PLANNING, ZONING, & BUILDING DEPARTMENT
PZ&B Staff Combination Memorandum: Town Council and Architectural Commission

SUBJECT: ZON-24-045 (ARC-24-038) 207 PENDLETON AVE (COMBO)

MEETING: APRIL 24, 2024, ARCOM
MAY 15, 2024, TC

The applicant has submitted plans, entitled "ENTRY RENOVATION 207 PENDLETON AVENUE", as prepared by **Kirchhoff & Associates Architects**, date stamped by the Town, April 8, 2024.

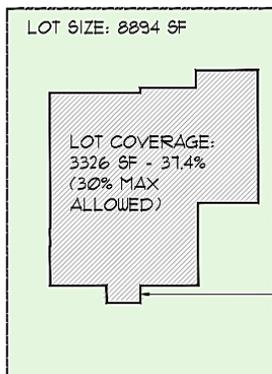
VARIANCE REQUIRED
 SECTION 134-893 (11) A
 REQUEST FOR A
 VARIANCE TO ALLOW THE
 FRONT ENTRY ADDITION
 TO HAVE A 37.4% LOT
 COVERAGE IN LIEU OF
 THE 30% EXISTING AND
 THE 30% MAXIMUM
 ALLOWABLE.

ADDED
 COVERAGE:
 24 SF

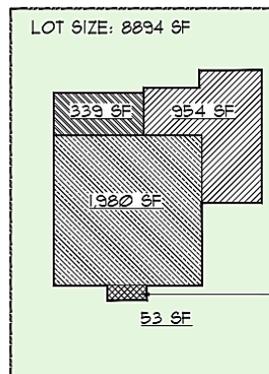
VARIANCE REQUIRED
 SECTION 134-893 (13) A
 REQUEST FOR A
 VARIANCE TO ALLOW THE
 FRONT ENTRY ADDITION
 TO HAVE A CUBIC
 CONTENT RATIO (CCR) OF
 4.52 IN LIEU OF THE 4.31
 EXISTING AND THE 4.31
 MAXIMUM ALLOWABLE.
